Northgate Apartments Phase II

EARLY DESIGN GUIDANCE - 2ND MEETING
NOVEMBER 5, 2018
PROJECT #3030779

BOARD COMMENT SUMMARY (EDG 1; AUGUST 6, 2018)

1D SUN ACCESS AT COURTYARD AND EASEMENT

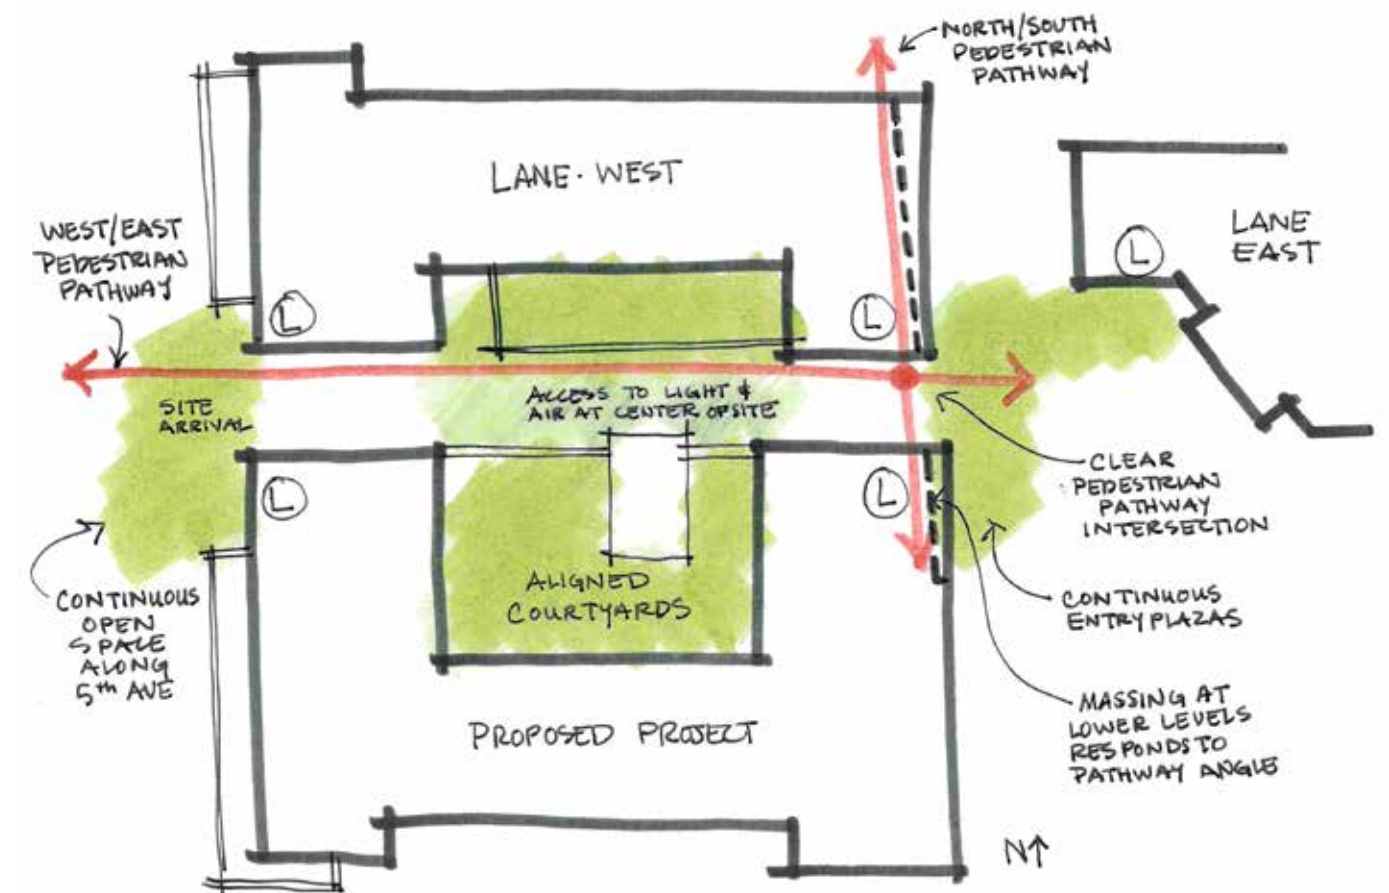
1D The Board provided guidance to further study the relationship and massing response between the proposal and the Lane Apartment structures, including sunlight access and the angle of the east building. (CS2-C-2, DC-2-A)

RESPONSE: The proposed project orients the courtyard North to both mirror the tower massing of the adjacent Lane Apartments project while also pulling the tower away from the access easement and the pedestrian environment. This design gesture reduces the perceived massing from the pathway and maximizes daylight for both projects for the greatest number of dwelling units as well as both open space courtyards. The North courtyard also provides access to light and air for the pedestrians at the grade level. Rather than mimic the angle of the Lane Apartments East Building massing, the project proposes to angle the massing of the East lobby parallel to the North-South pedestrian connection. The angle of this massing provides an opportunity for an East Plaza area which establishes a strong connection to the continuation of the pathway as well as compliment the central arrival area created by Lane Apartments. See page 29 for examples of the massing at the common courtyards. (DC2-A, PL1-B)

COMPOSITE SITE PLAN WITH ACCESS POINTS AND GROUND LEVEL USES

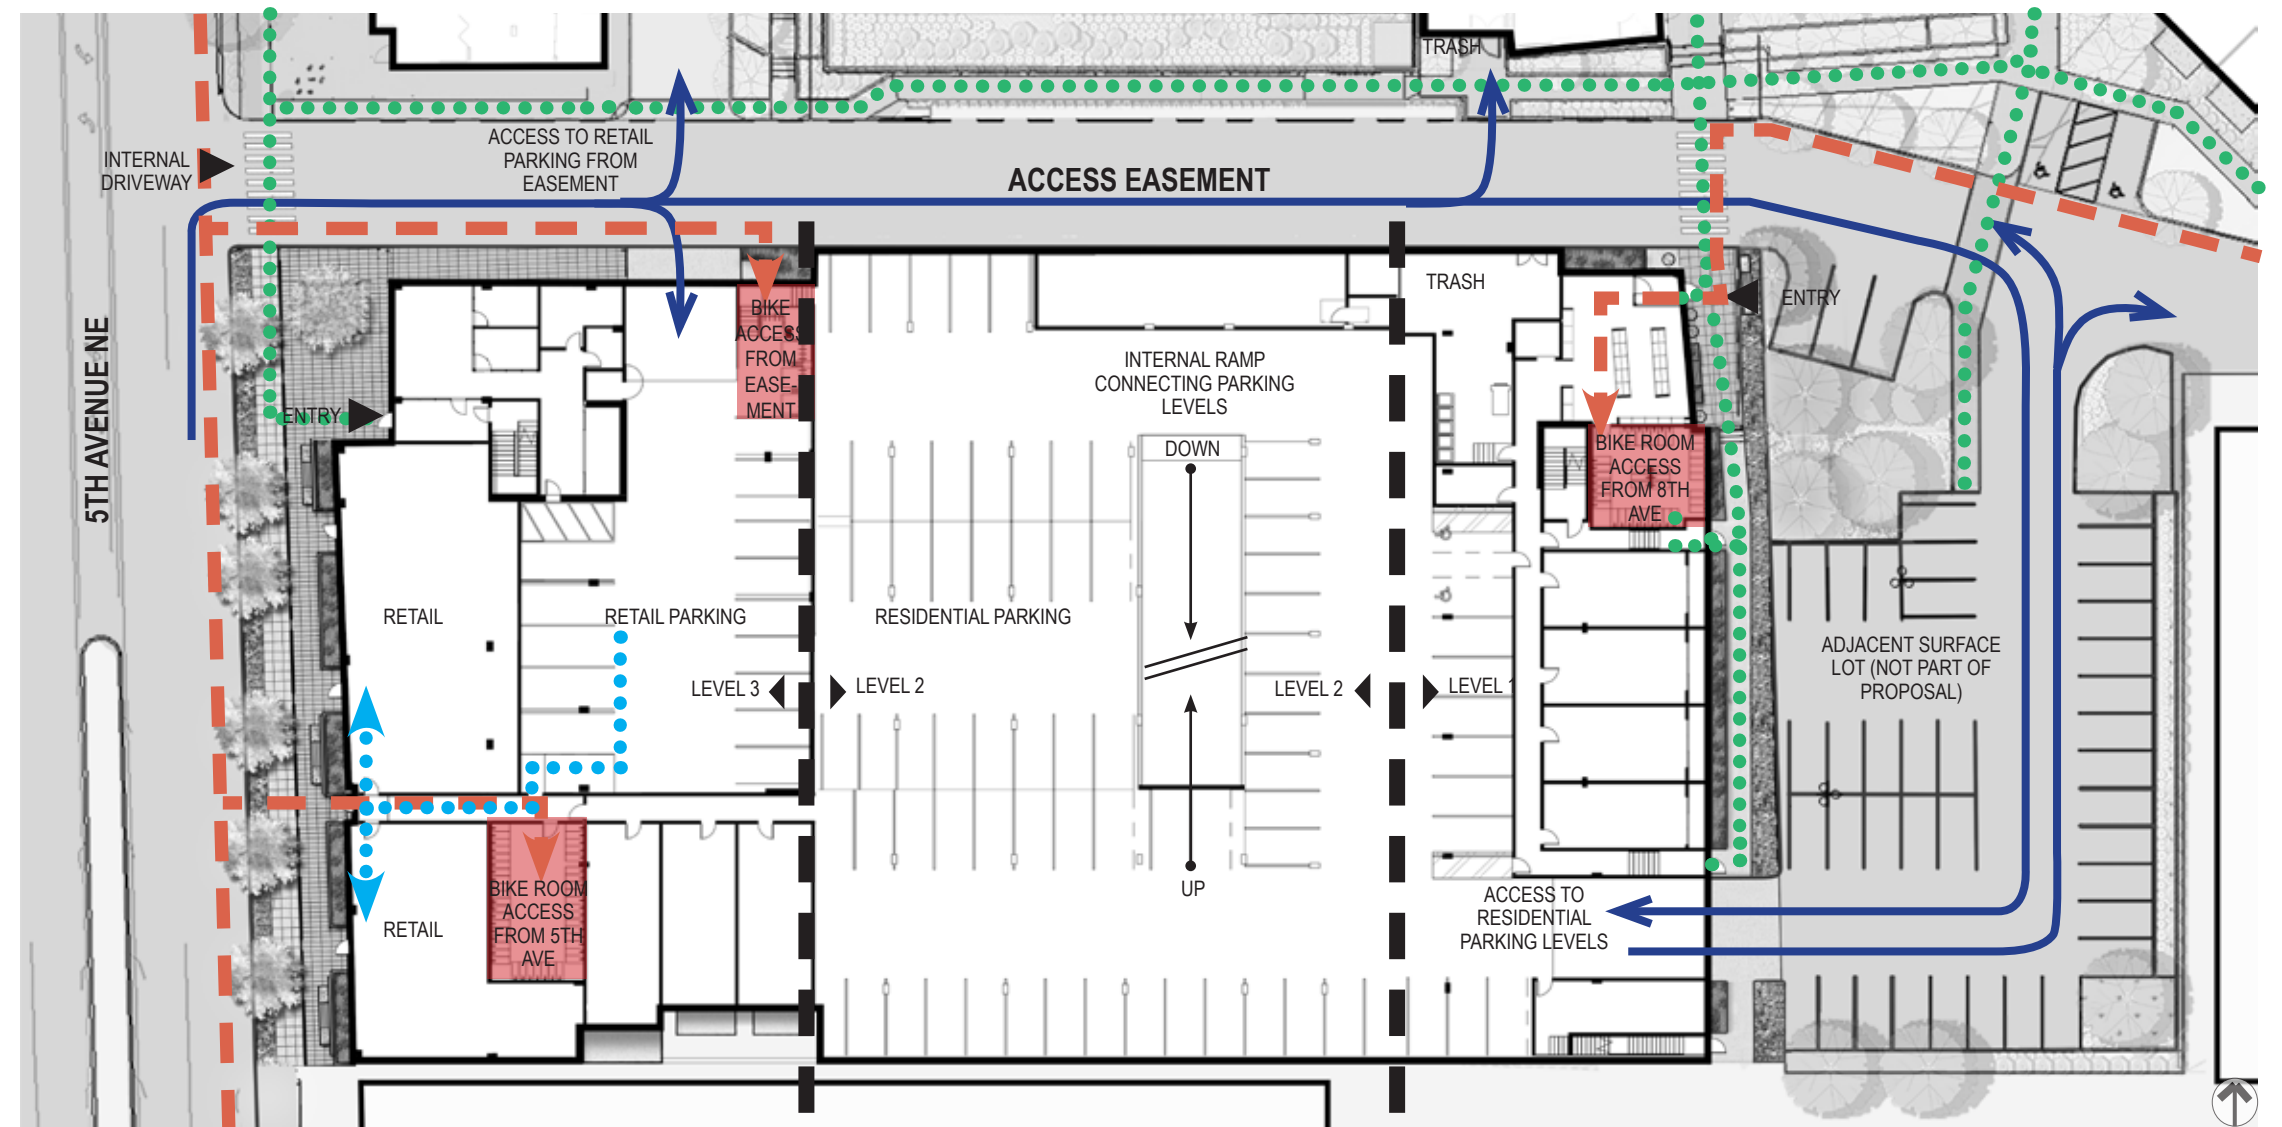
- 2A The Board agreed that the massing was predominately focused on vehicular access and provided guidance to prioritize pedestrian and bicyclist access over vehicles. (PL3-I, PL4-B, DC1-C)
- 2B The Board was concerned with the number of garage entry points and the negative impact to the pedestrian experience and safety. The Board provided guidance to minimize garage entry points and create efficient vehicular access, including study of combined internal vehicular access. Multiple garage access points should be justified by the Design Guidelines. (DC1-C, PL3-I)

- 2C The Board discussed the proximity to transit and future light rail station and gave guidance to provide bicycle access and storage from the 5th Avenue NE facade that is easily accessible and adequately sized. (PL4-B, PL4-C)

RESPONSE: Per the Board's guidance, a residential garage vehicular access along the access easement has been eliminated to reduce pedestrian / vehicular conflicts and reduce the visual impact of the parking uses. Primary residential vehicular access to the parking garage is provided through the Eastern adjacent surface parking lot and the parking garage has been redesigned to include an internal speed ramp to access the upper level of parking. The elimination of the parking access from the easement removes the visual impact of the garage opening from the pedestrian realm, reduces the volume of turning traffic and sightline impacts, and allows for the other more active interior uses to be located along the north facade, such as the amenity spaces, to activate the access easement and reduce blank walls. In order to support the success of the retail spaces, parking dedicated to retail is provided as no street parking is present along 5th Ave. The project proposes to retain the retail vehicular entry along the access easement in order to provide a direct and convenient pathway for pedestrians to the 5th Ave retail location as encouraged by the Northgate Guideline DC1-IV Community Goals. A sidewalk from the garage to 5th Ave is provided in addition to convenient internal entries directly into the retail areas. The parking garage is located behind the retail uses along 5th Ave, as encouraged by Northgate Guideline DC1-IVii Locate Parking to Rear (along 5th Avenue NE). The location of both Lane Apartments and the proposed curb cuts across from one another is ideal in terms of minimizing risk of turning traffic collisions while simultaneously consolidating areas of potential pedestrian / vehicle conflicts.

RESPONSE: The project welcomes the close proximity to transit and celebrates it by encouraging the use of bicycles via extensive bike parking on the premises. The project provides three main bike parking areas, which are conveniently located near major site arrival points. A long term bike parking room added to level 3, with ride-up access off 5th Avenue NE, houses 44 bikes. At the eastern lobby at Level 1, a second long term bike room is located immediately off the main lobby for ease of access and houses 39 bikes. Both locations have ride-up access from the exterior. Short term bike parking at the retail parking garage for both retail and residential guests has been provided with a separate entry from the retail driveway to avoid bicycle and vehicular conflicts. Additionally, in anticipation of high bicycle transit use, within one of the long term bike rooms, the project proposes bike wash and repair stations.

2D DESIGN RESPONSE CHANGES TO PEDESTRIAN EXPERIENCE DEVELOPMENT ALONG EASEMENT

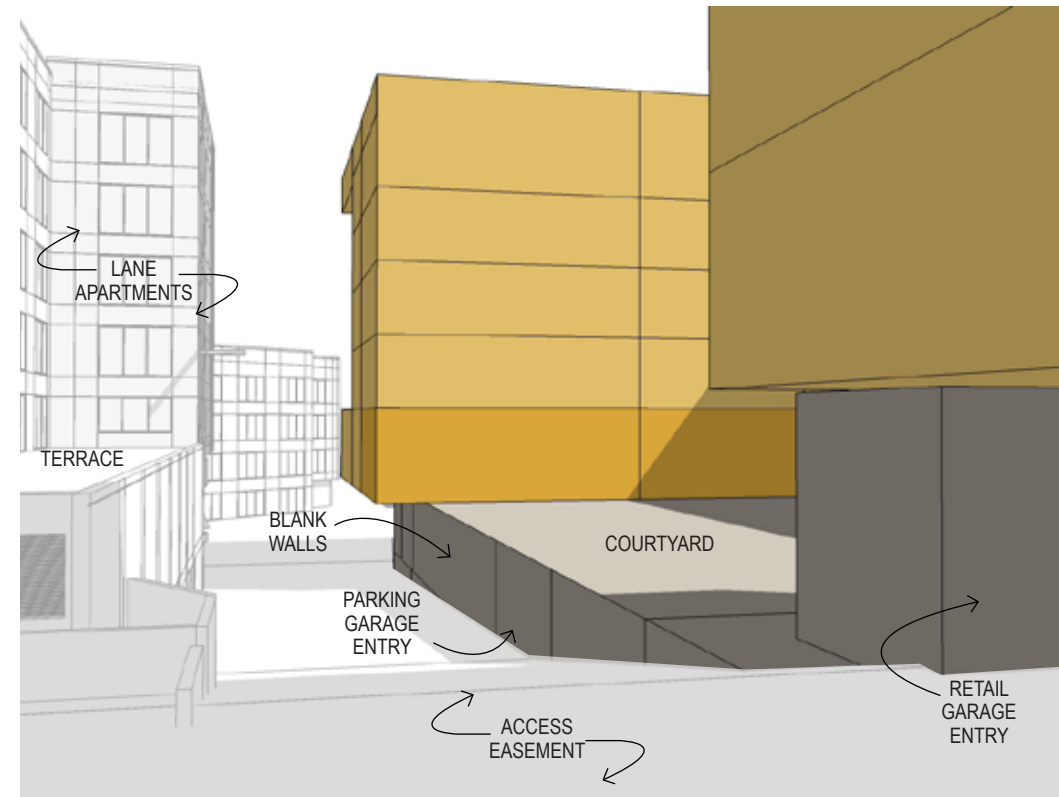
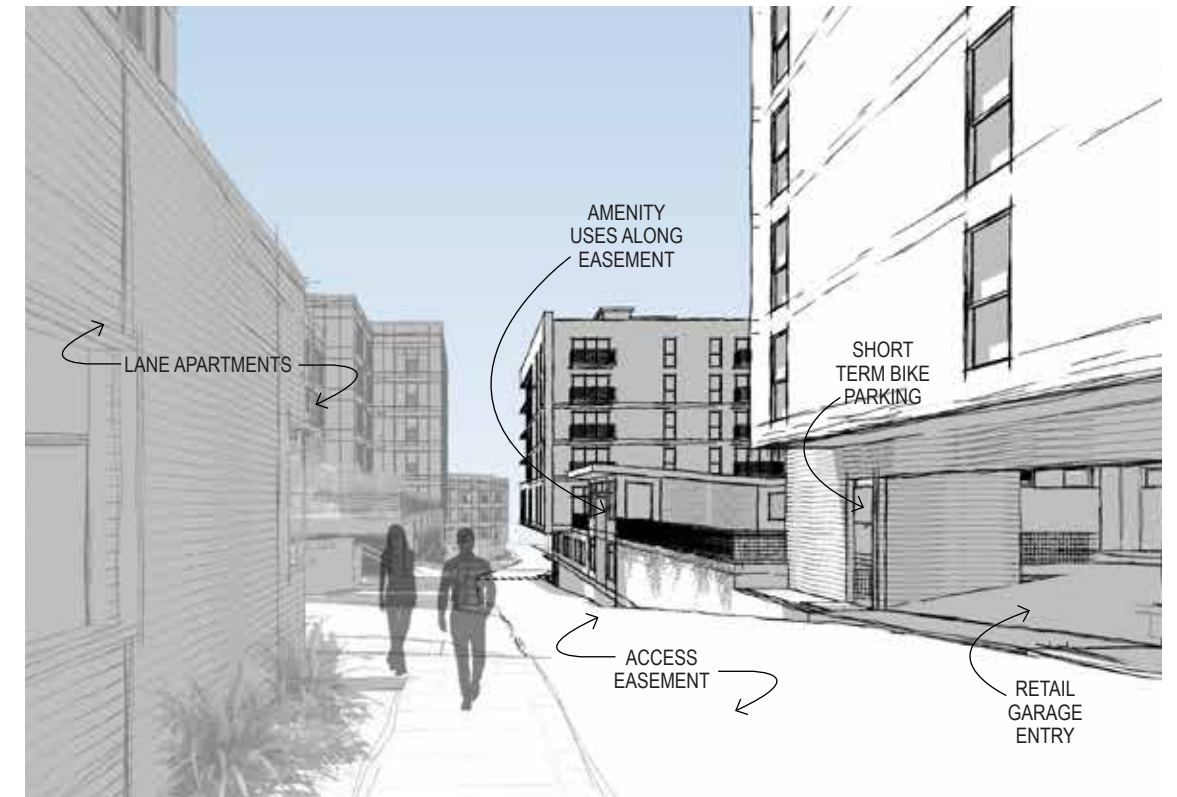
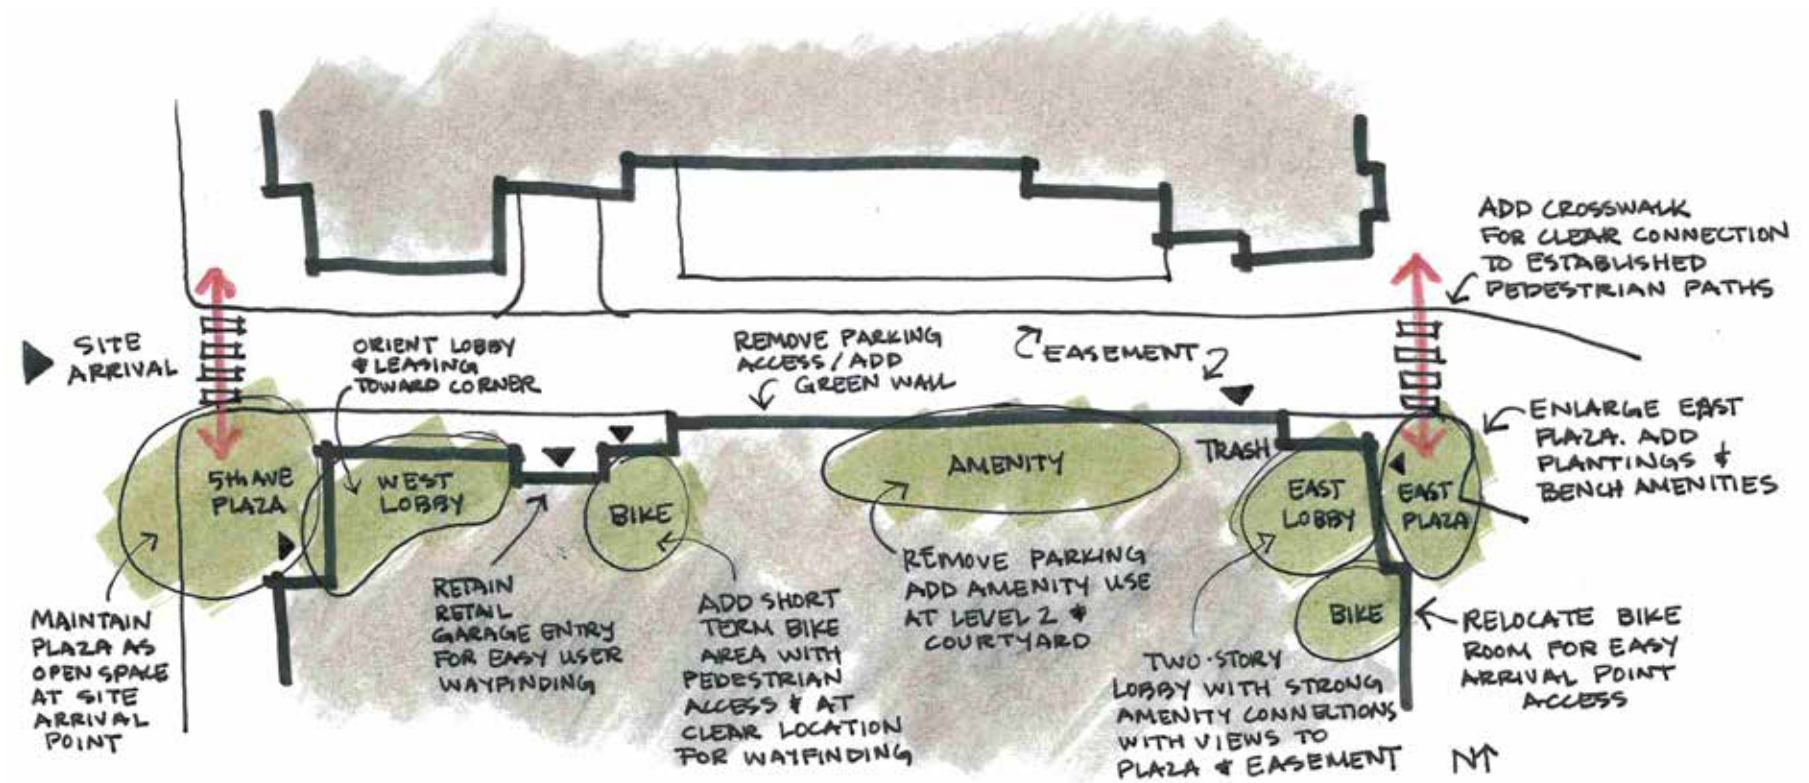
2D The Board felt the massing options created a canyon-like experience of garage walls through the access easement. The Board provided guidance to further develop the character of the access easement, creating a pleasant pedestrian experience and considering how safety will be addressed. The Board also provided guidance to integrate the courtyard with the pedestrian experience through the access easement. (PL3-I)

RESPONSE: The project proposes the following strategies to create a pleasant and safe pedestrian experience: Removing one of the vehicular entry points from the easement to reduce potential pedestrian and vehicular conflicts, locating active uses along the lower story massing (such as amenity spaces, bike room entry, and exterior plaza spaces) to engage the exterior sidewalk space, buffer the visual impact of the parking use with other more active uses where the steep grades allow for transparency and employ green wall strategies where transparent uses are infeasible. In addition, the Northern facing courtyard allows upper level setbacks along the internal walkway bringing sunlight to the sidewalk. At the courtyard level, a relocated Amenity Lounge provides an active use along the courtyard edge. Flanking the Amenity Lounge are generous planters which provide visual interest and an opportunity for sun exposure for cascading plantings to create green walls at blank wall locations along the easement. For more information, please see the project's response to item 1C, pedestrian scale and additional studies on sheet 29. (PL3-III)
